DESCRIPTIVE REPORT

Field No. H11838 _____

General Locality _____ Northern Cook Inlet _____

Sublocality: **Point Woronzof to Fire Island Shoal**

Figure 1 – Overview of H11838 with Chart 16663, 8th Edition, March 2006. Soundings in fathoms.

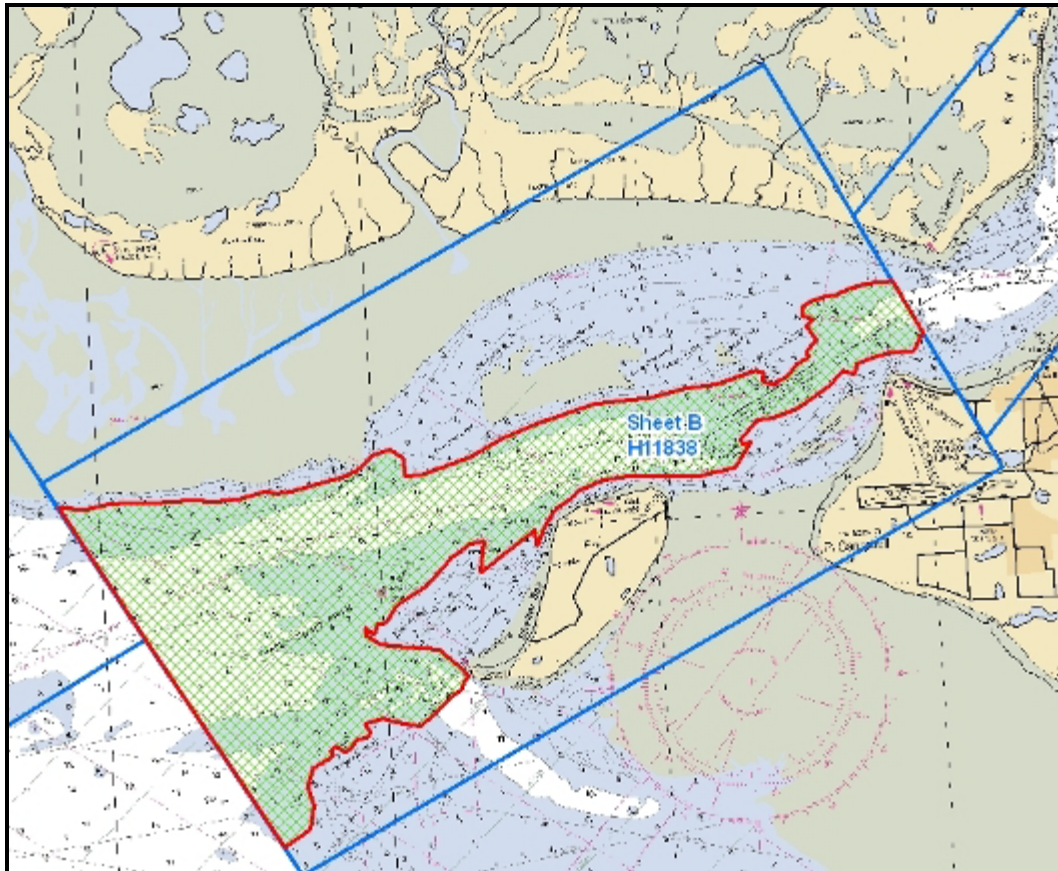
Sonar and Side Scan Sonar Services, OPR-P385-TE-08, dated March 3, 2008. **Concur with clarification. Refer to the Revised SOW (12 February 2010) for further explanation about side scan sonar data requirement and this survey.**

Figure 4 – Positions of H11838 sounding discrepancies on chart 16665

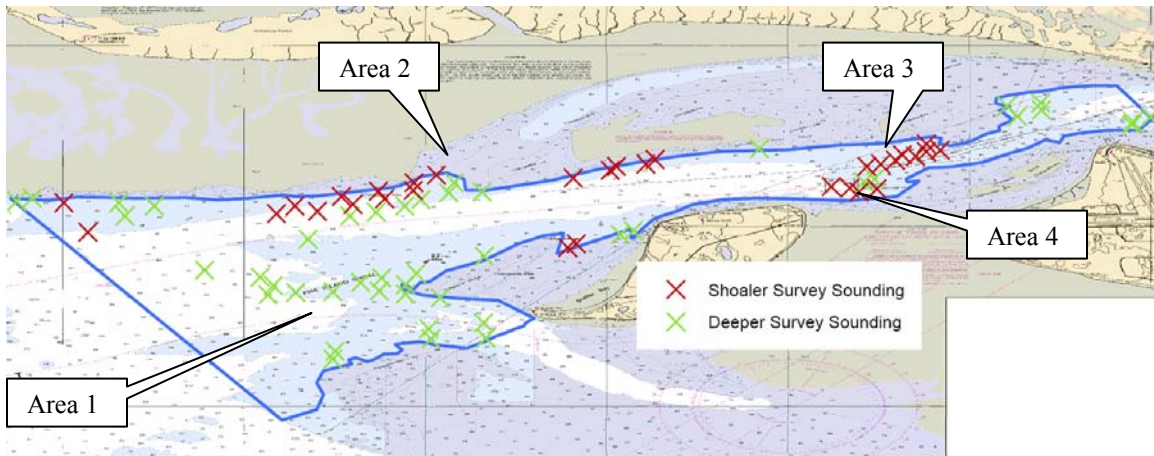
These significant differences (generally those greater than +/- 10 % of charted depth) are itemized in the table below. It is recommended that soundings from H11838 supersede previously charted soundings.

Sounding discrepancies that qualify as DTONs are itemized in the sounding discrepancy table in section D.1.3. **Concur with clarification. A total of 28 Soundings were submitted to AHB and charted by MCD as Dtons (see Appendix I).**

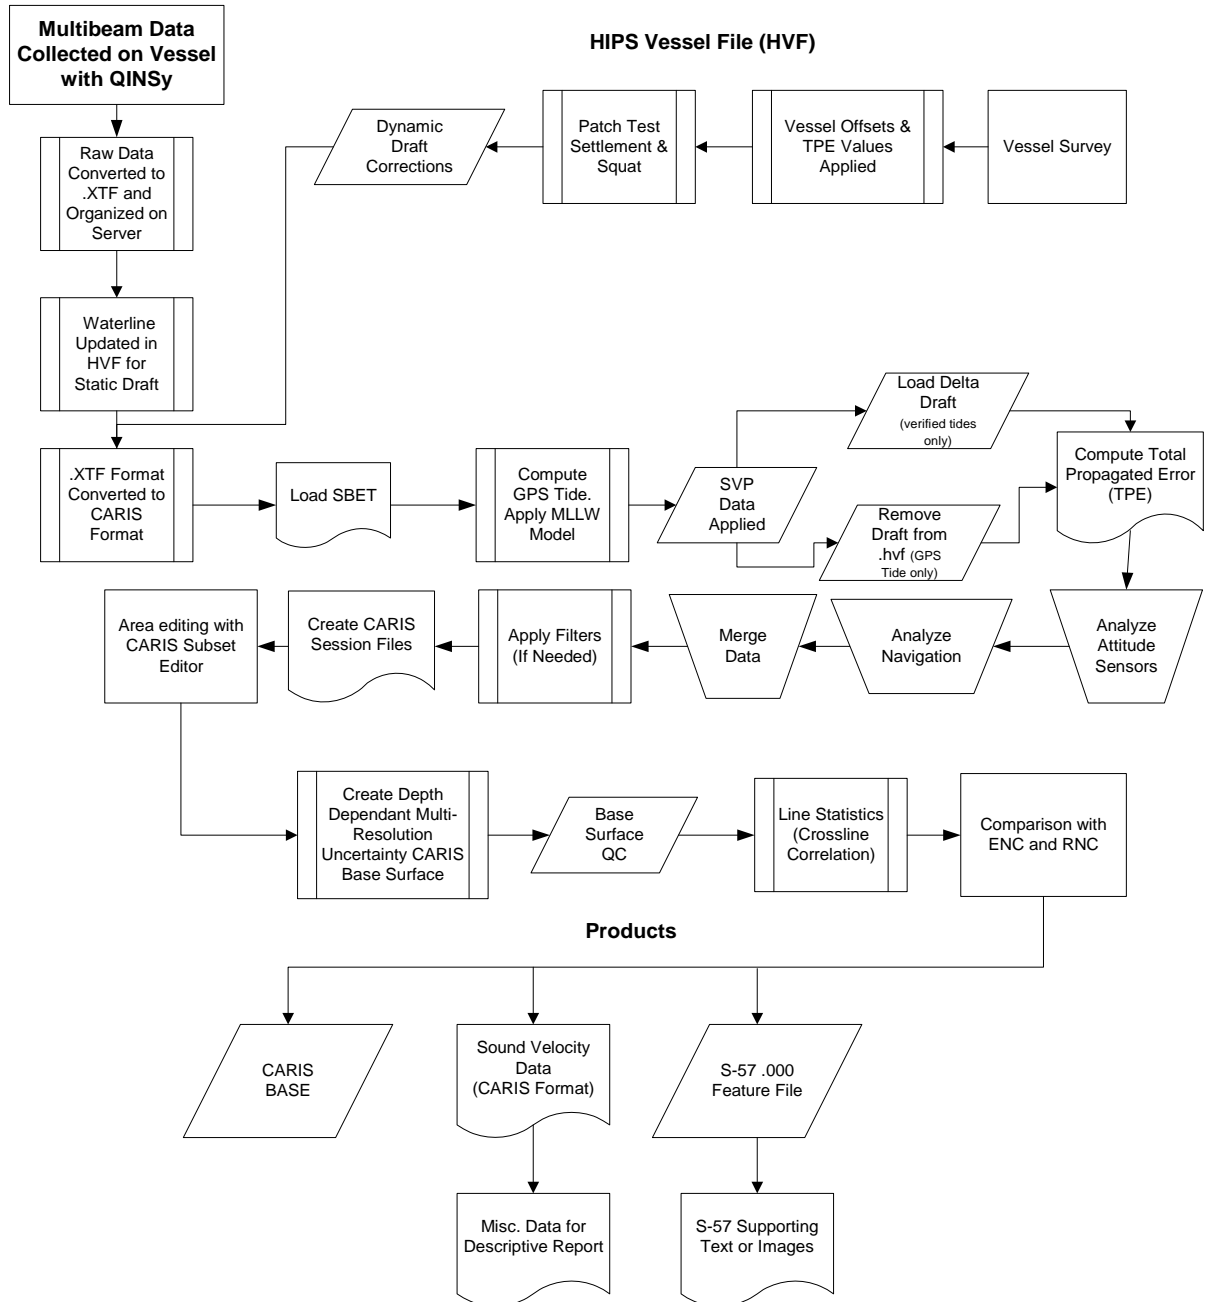
DAPR Section B.6 Field Data Processing (pg. 20) data acquisition and reduction flowchart needs to be amended to reflect the removal of speed-based dynamic draft

values from the vessel file associated with survey lines processed with PPK-based GPS tide and the loading of rpm-based delta draft values for those lines processed with verified tides and zones.

The following diagram should replace *DAPR Section B.6 Field Data Processing* (pg. 20):

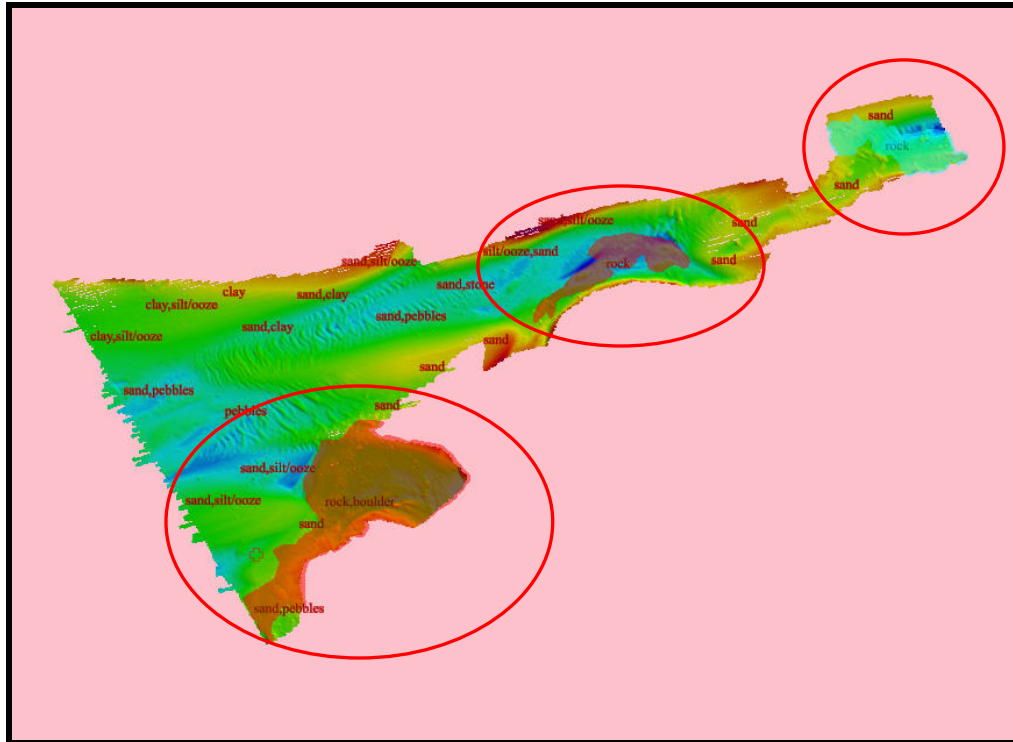
- a. The field unit collected a total of 39 bottom samples. Samples were deleted in channels and areas that encompassed a rocky seabed area. Seabed characteristics were applied to the chart appropriate to the chart scale and navigational requirements.

One seabed characteristic was deleted due to location in channel.

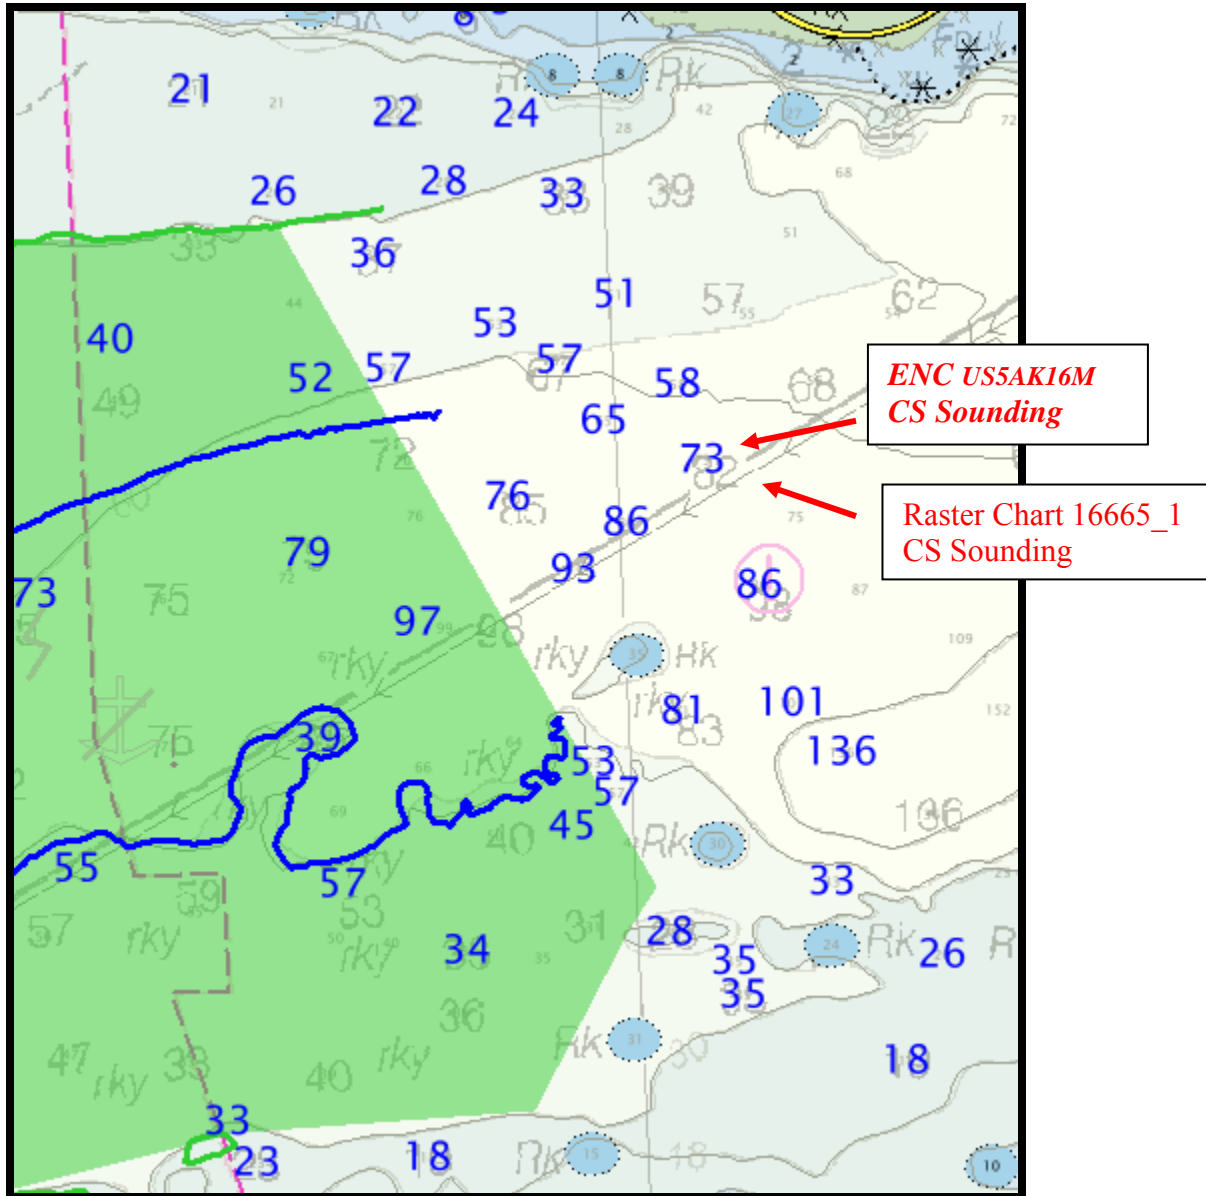
- d. ENC US5AK16M (Updated 11/16/2010) CS Soundings do not coincide with RNC 16665_1 (1:20,000).

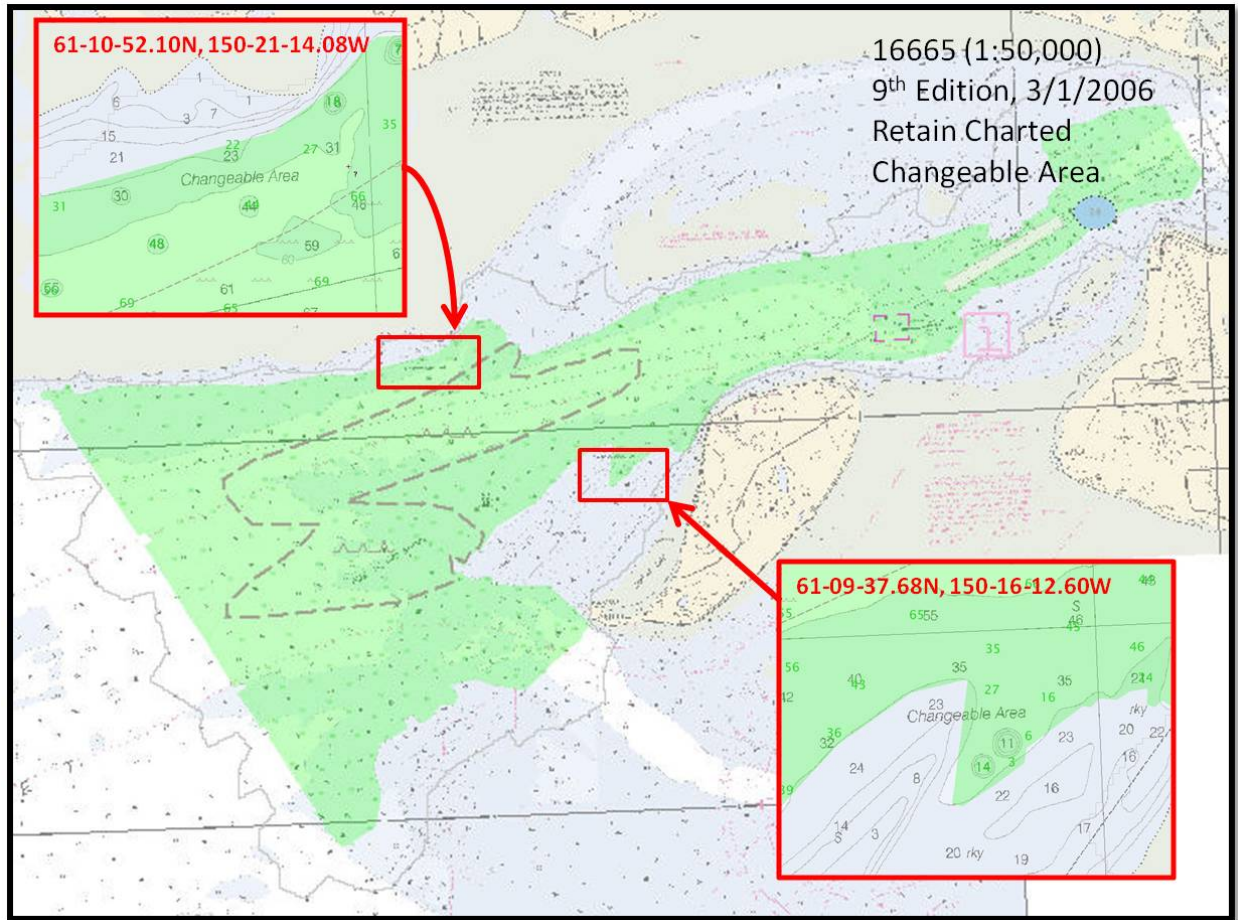
- e. Charted "Changeable area notes (chart 16665) at 61-09-37.68N, 150-16-12.60W and 61-10-52.10N, 150-21-14.08W were found by this survey's data to suit conditions in the area. Both areas have changed considerably.

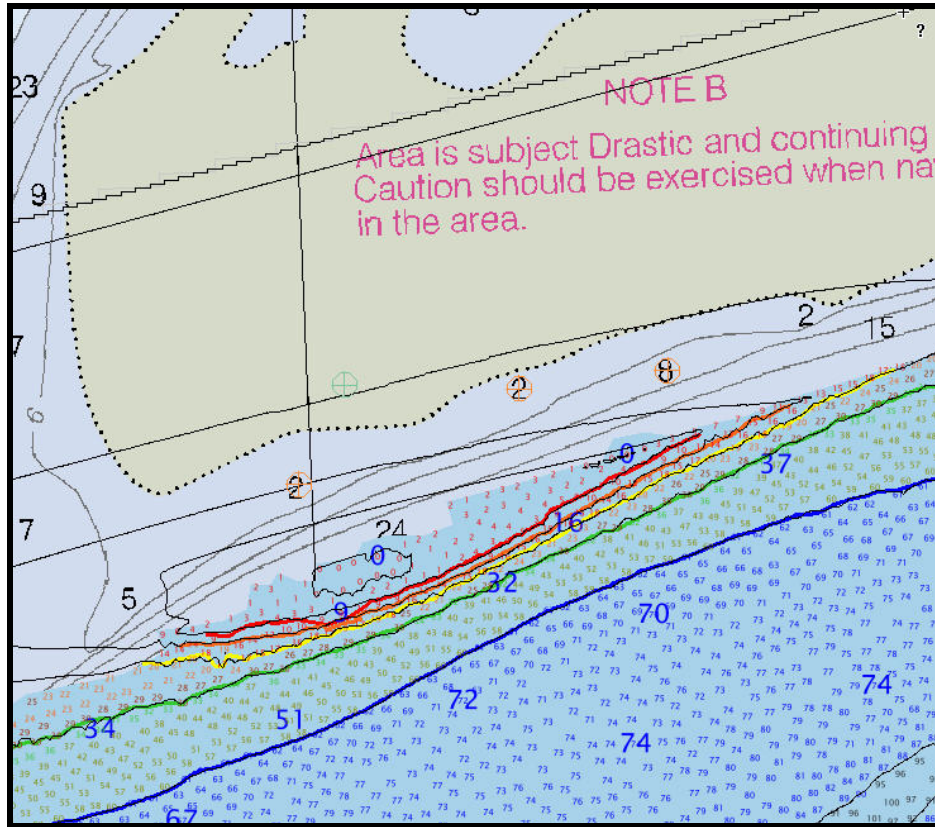
- f. The charted intertidal area should be contiguous with the survey intertidal area. Extend intertidal area to the south.
